**Product: Residential K-Base**

**Subject: 2K Test Adapter Advisory**

**Date: 1/7/2005**

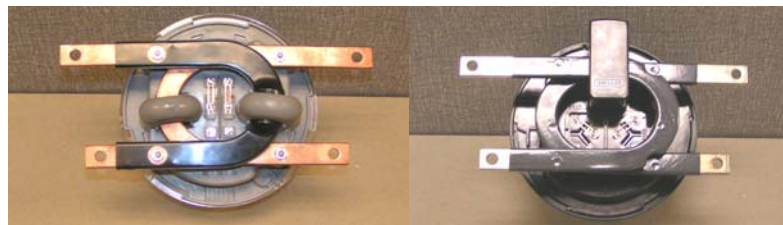
A new-design baseplate will soon be introduced on FOCUS® form 2K meters. This design utilizes two encased transformers in the meter baseplate opposed to the old design that used one large transformer. The old design was used on MS-2K and Altimus 2K meters.

This new design results in a need to modify existing 2K test adapters in order to work with the FOCUS 2K meter. Attached are photos comparing the old-style and new-style adapters and 2K baseplates.

All 2K Test Adapters, part no. 9707-8009, purchased from this date forward will be of the new design. **The new adapter design adapts to ALL 2K meters including MS, Altimus and FOCUS.**

Please contact Landis+Gyr Inc. for information regarding modification of existing old-style adapters in your possession.
